- 12/19/18 CK - COMPLETED DESIGN FOR CLIENT & CITY REVIEW.
- 02/18/19 CK - UPDATED PER CITY REVIEW COMMENTS.

Uintah View Estates Improvement Plans

OGDEN CITY, WEBER COUNTY, UTAH
DECEMBER 2018

Cover/Index Sheet

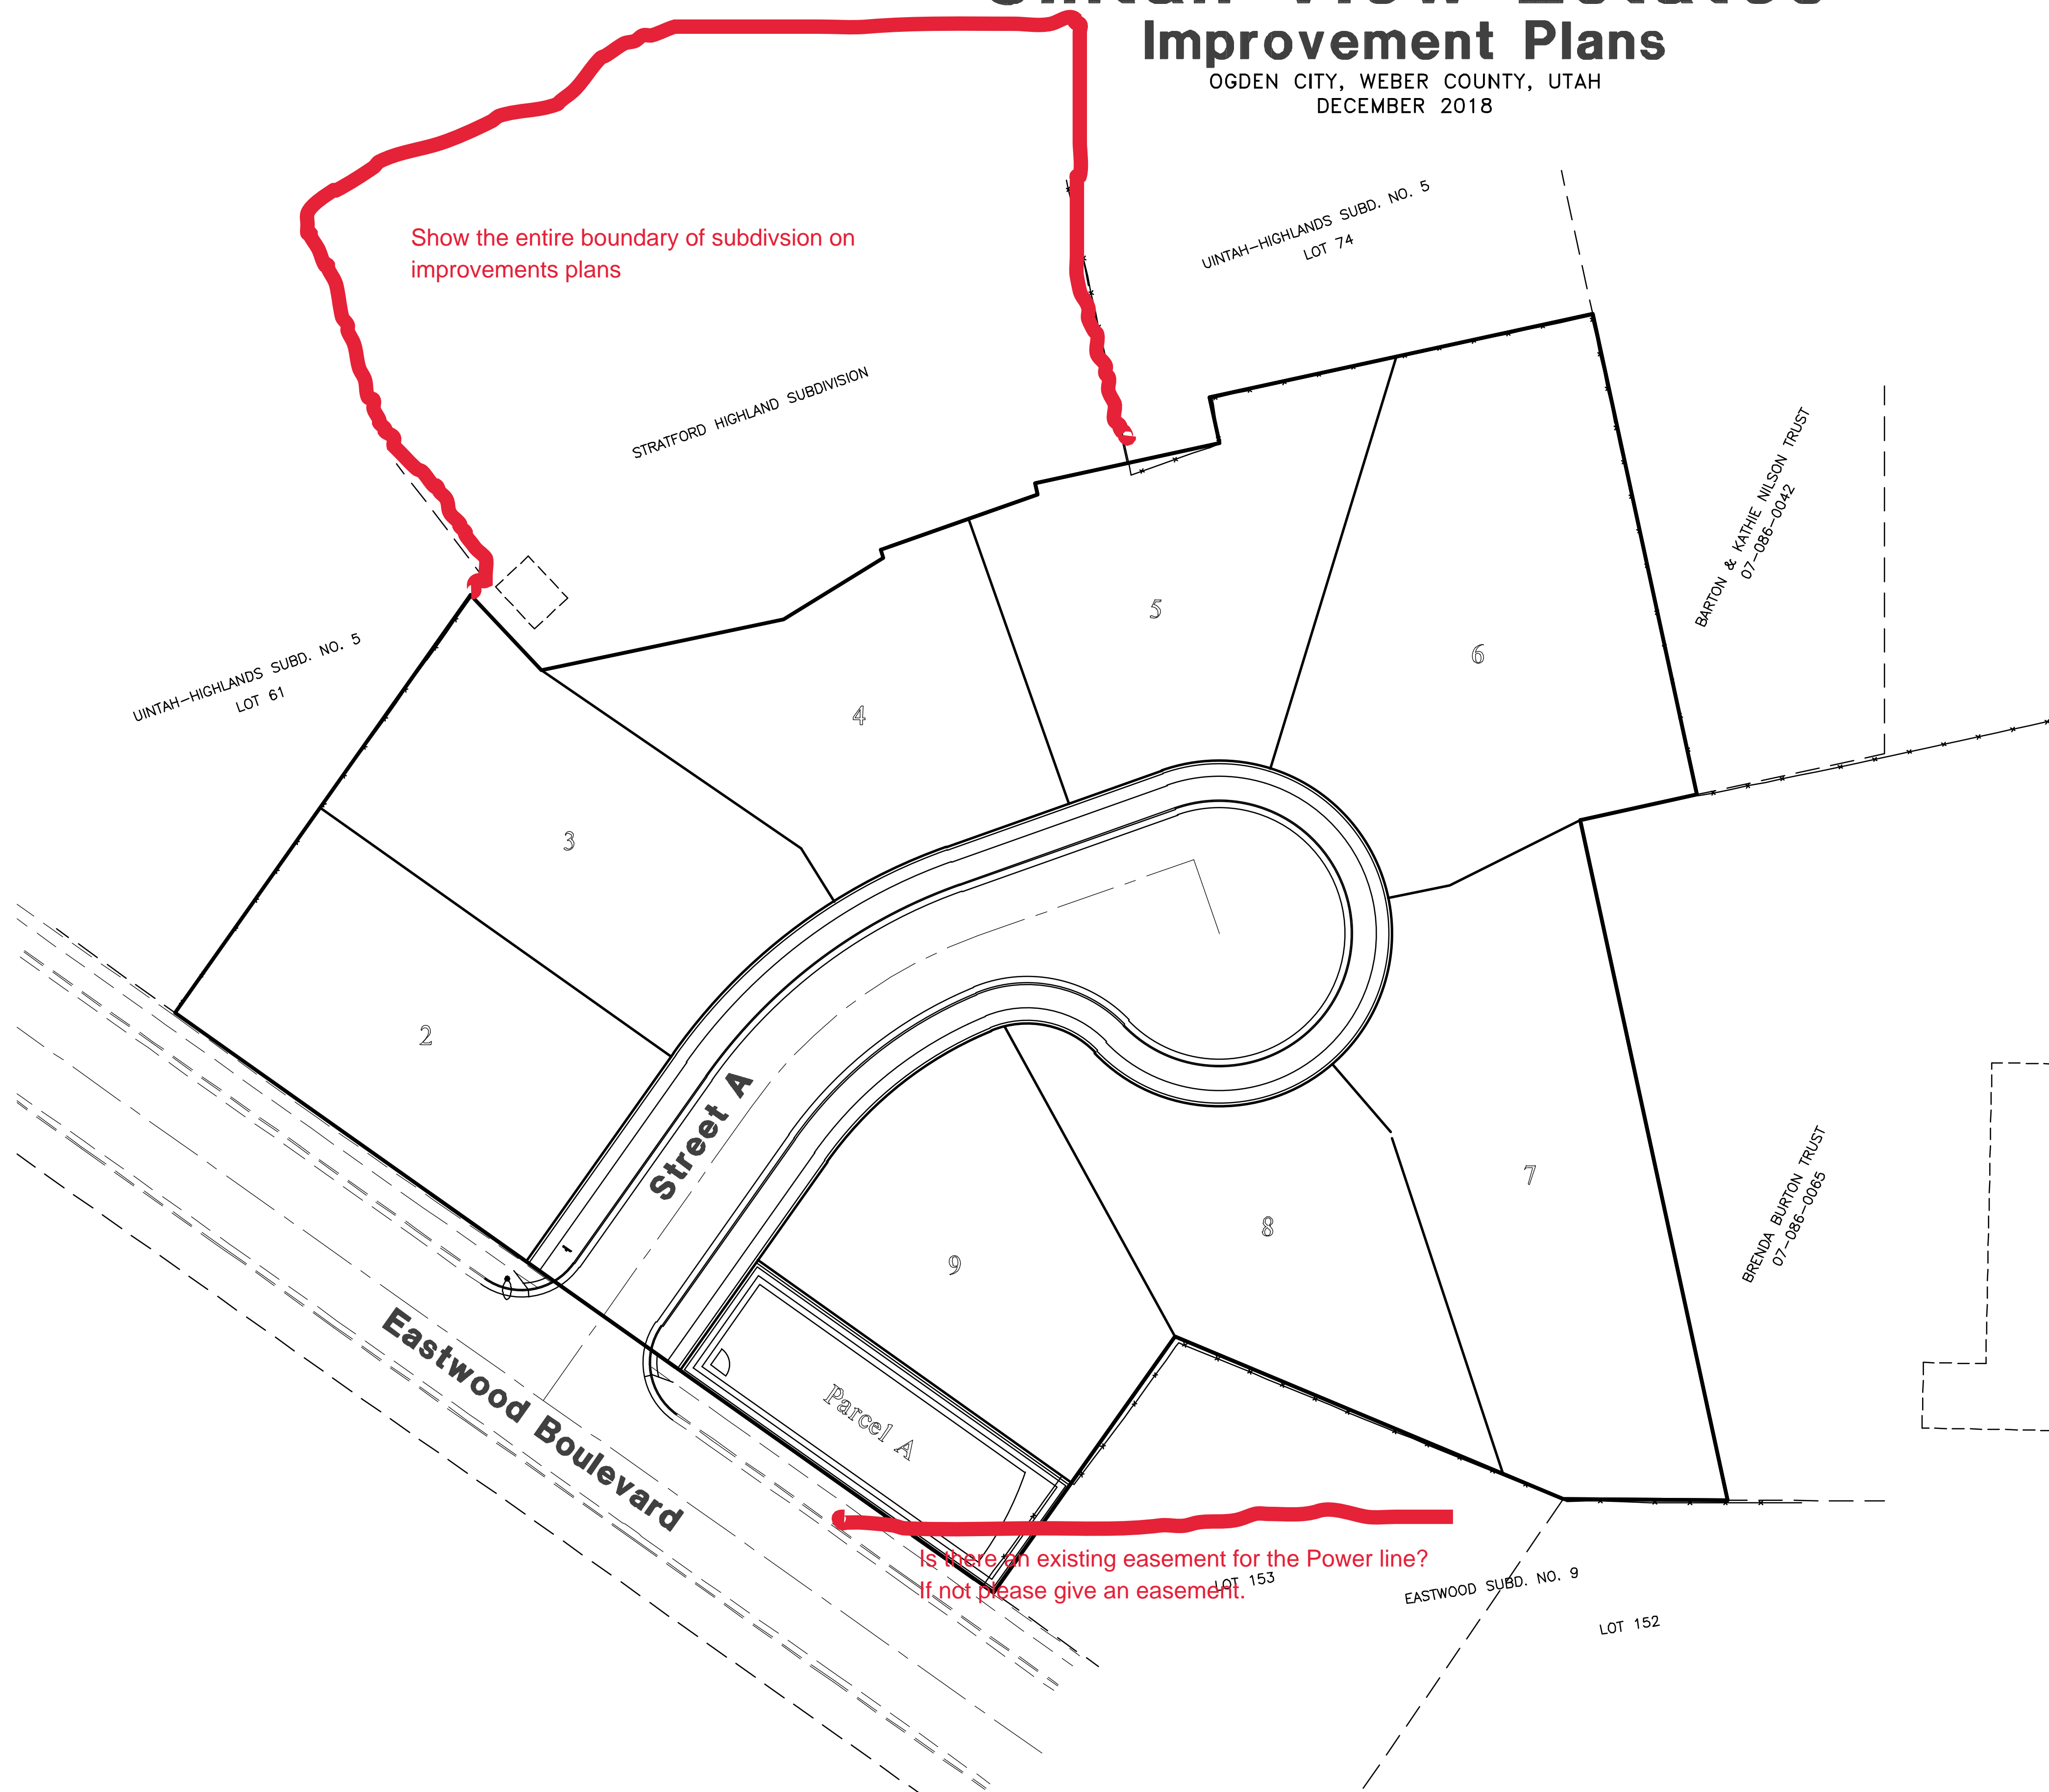
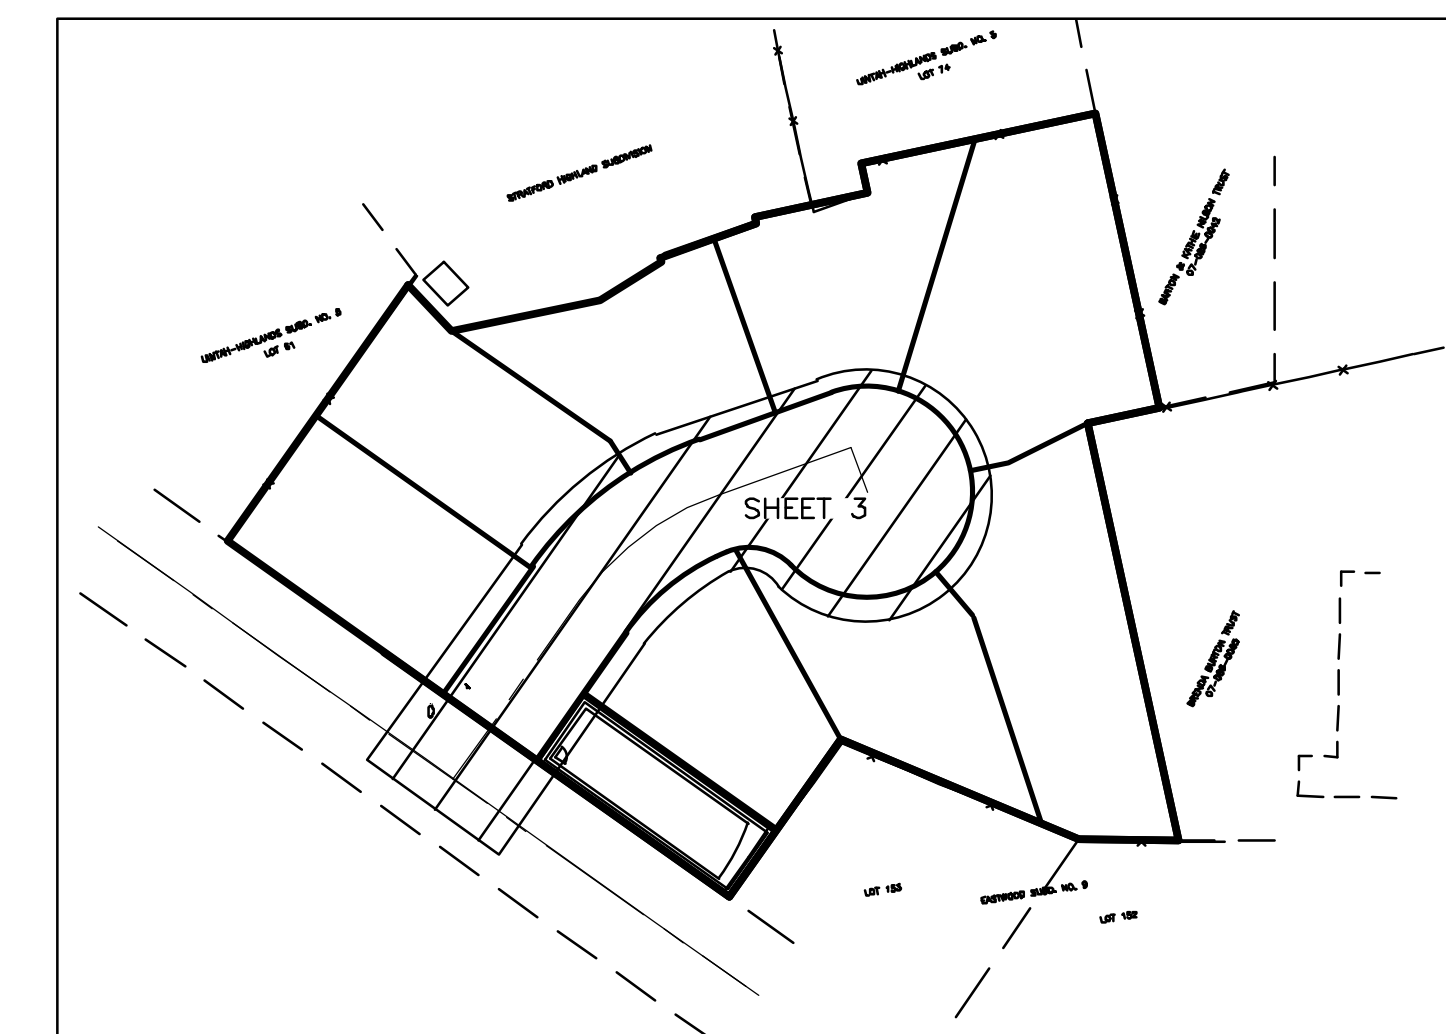
Show the entire boundary of subdivision on improvements plans

Is there an existing easement for the Power line?
If not please give an easement.

Street Section (60' R.O.W.)

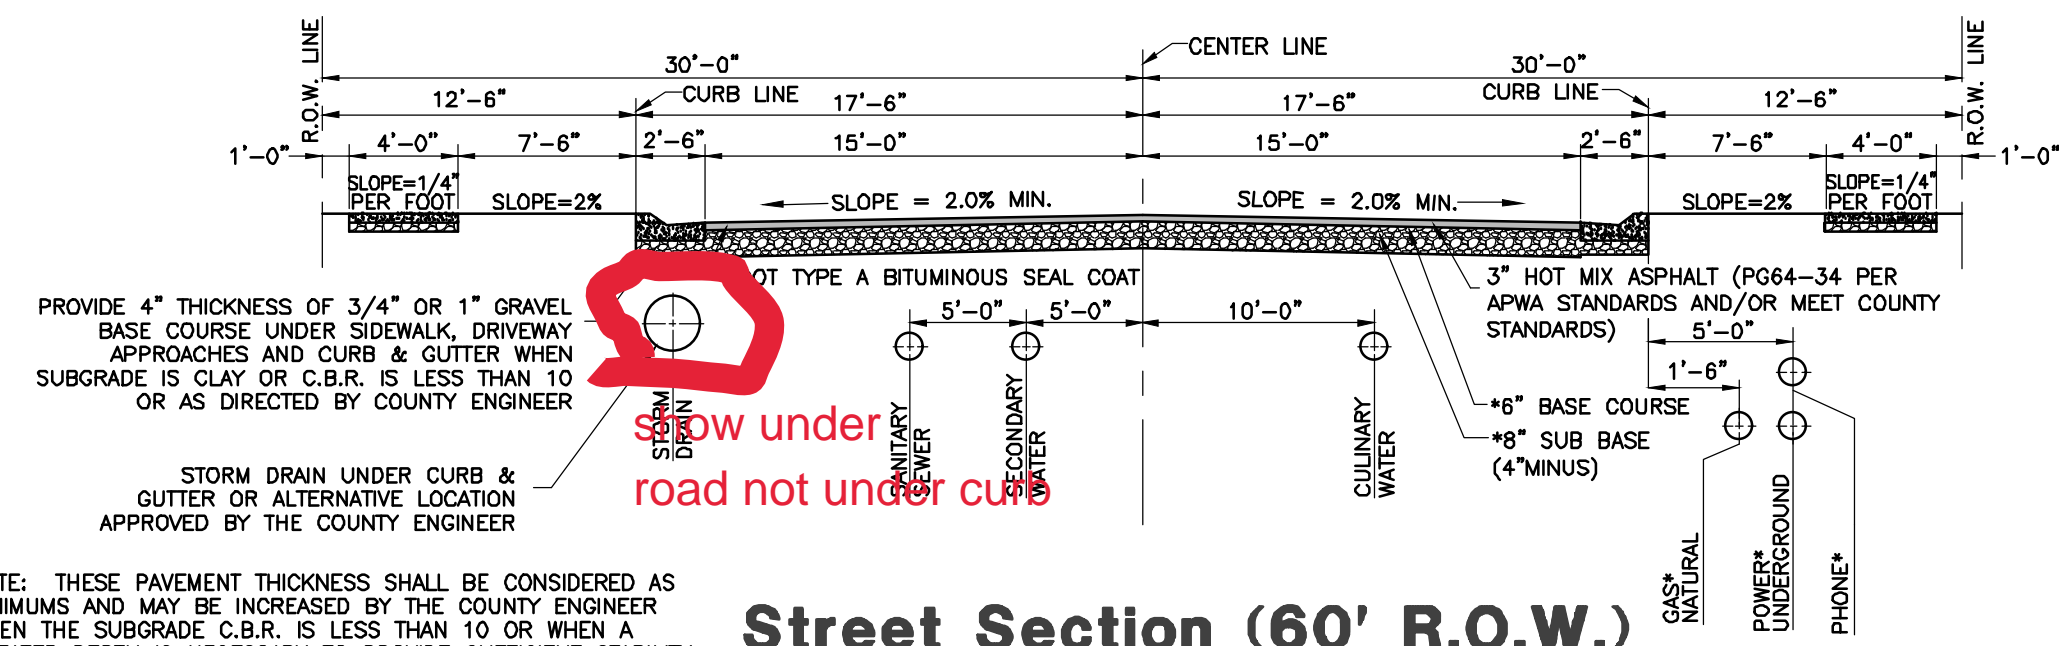
a minimum of 6" not 3" for the base course 3" THICK UNTREATED BASE COURSE

Street A
4+50.00 - 8+50.00

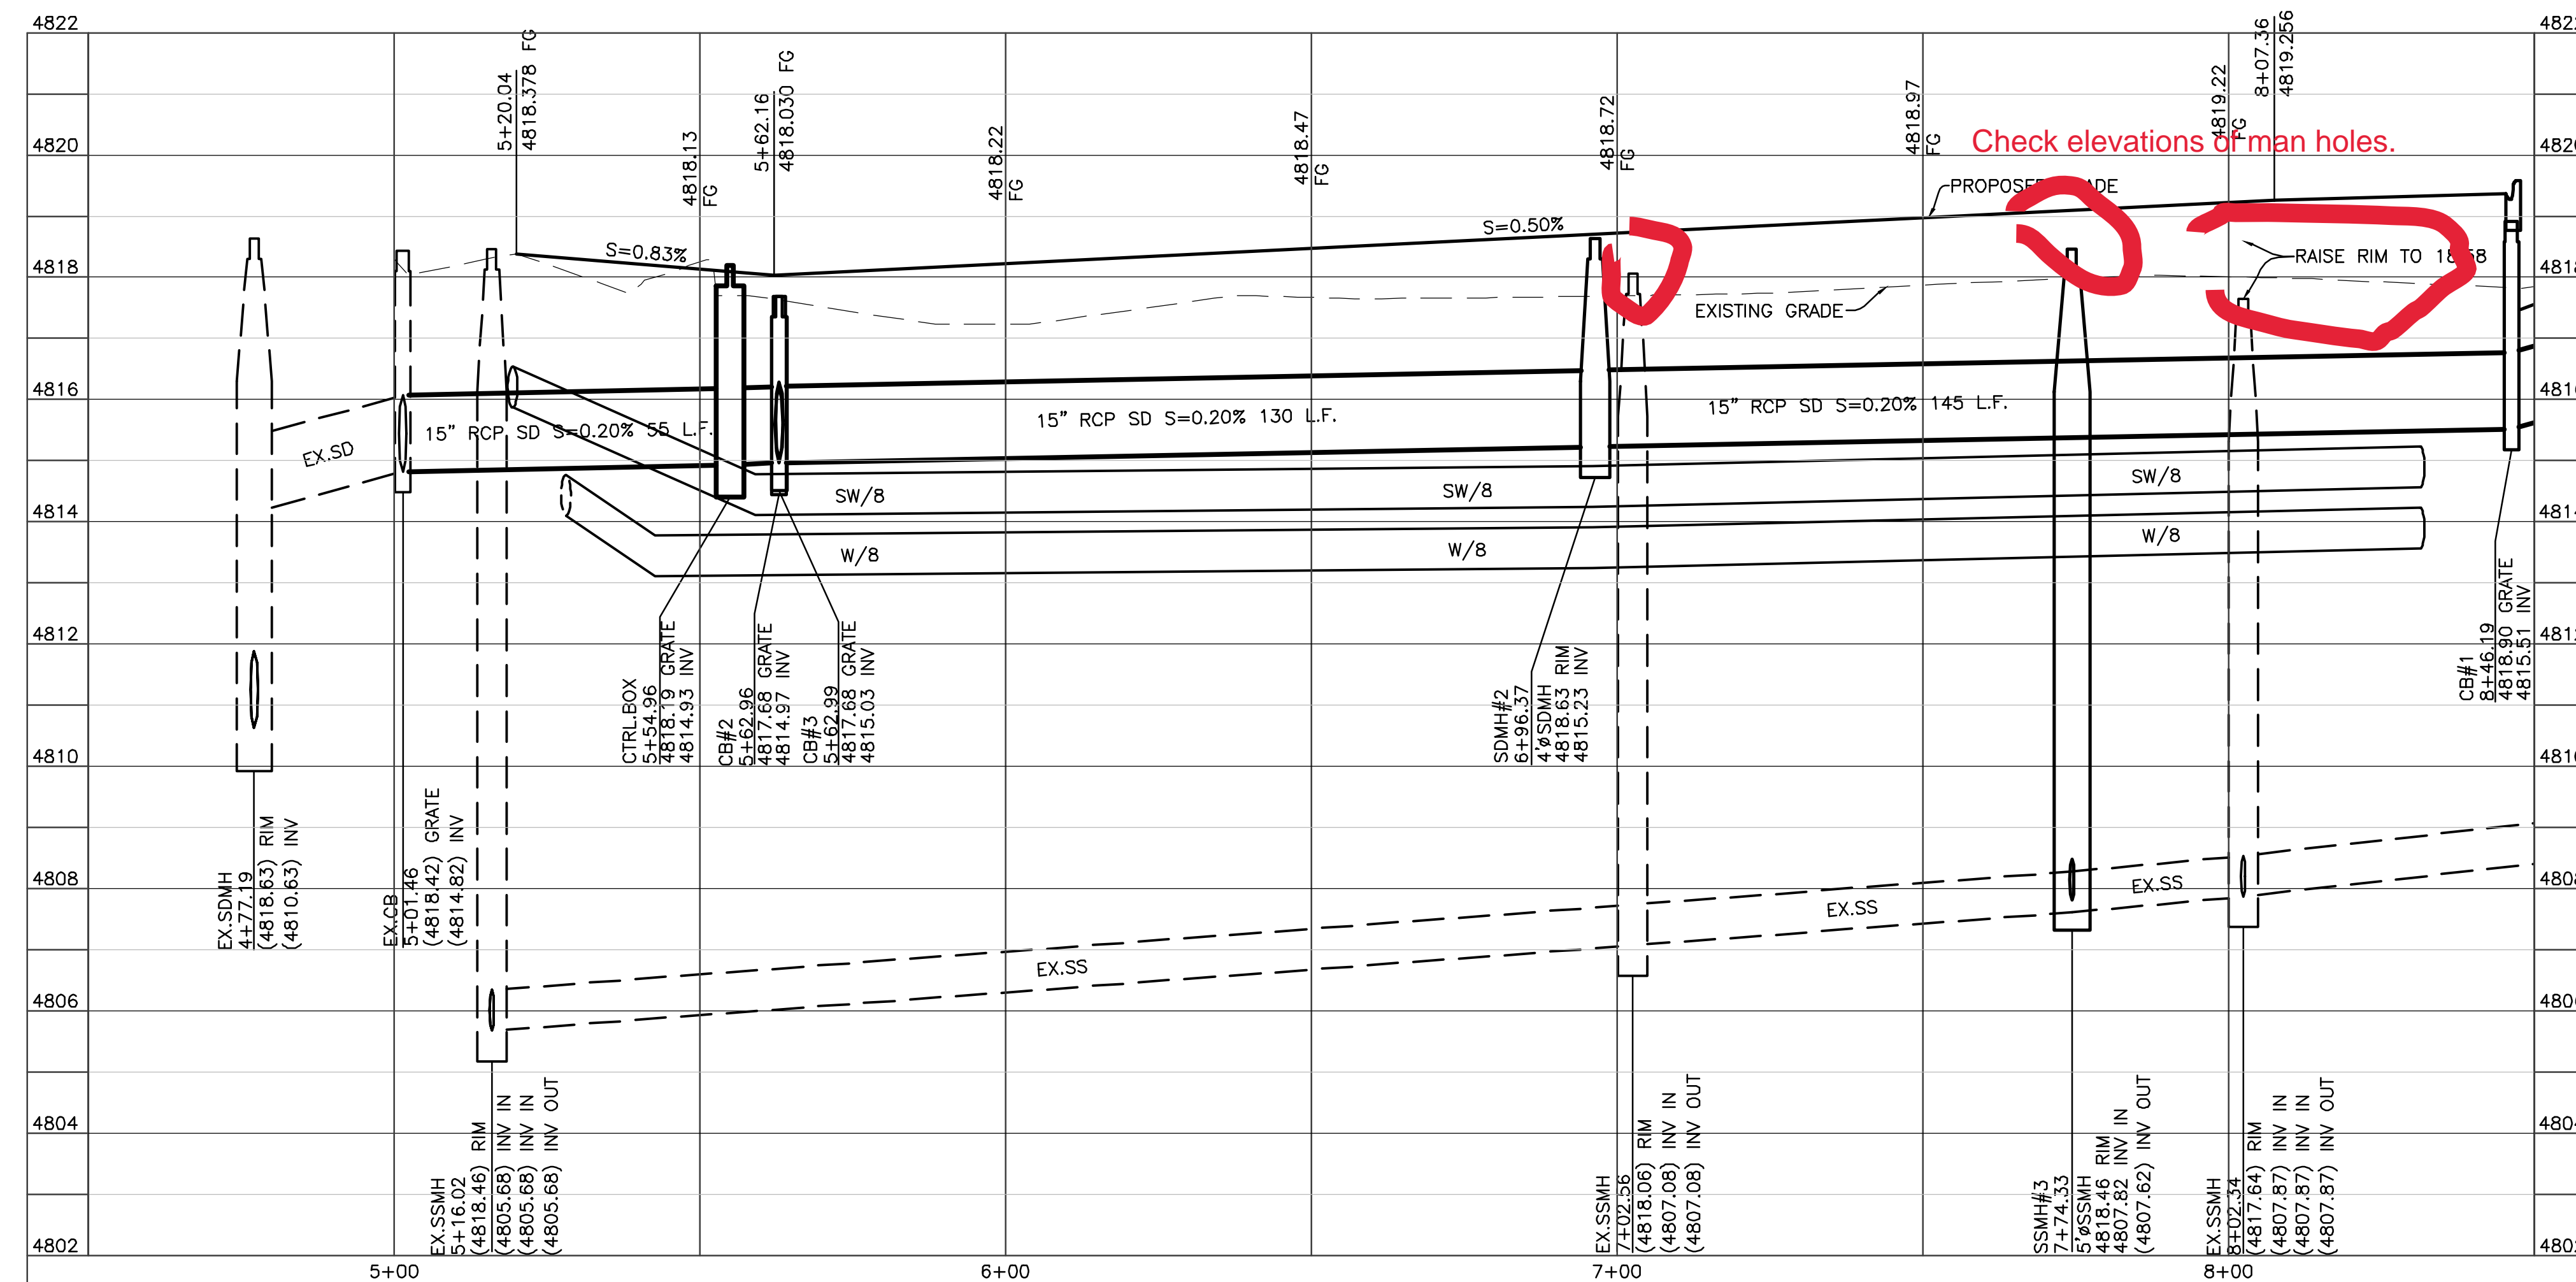
have the truncated domes oriented 90 degrees to new road. that way it pushes pedestrians across instead of out into eastward

Verify no conflicts for crossing of storm drain and water lines.

What is the name of the street?

Adjust utilities so storm drain is not under curb.

Instead of catch basin, use man holes in the roadway.

Check elevations of man holes.

Use either APWA specifications or Weber County specifications.
ADA truncated domes "gray"
